# Paper for Consideration by NCWG Action 8 to 11 – NCWG9

**Submitted by:** France

**Executive Summary:** Action NCWG9 8 to 11.

#### C – Sea bed activity. (NCWG9-8)

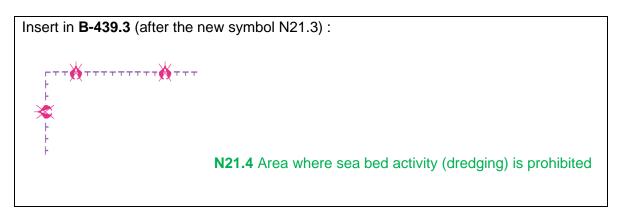
8. Proposed text for S-4:
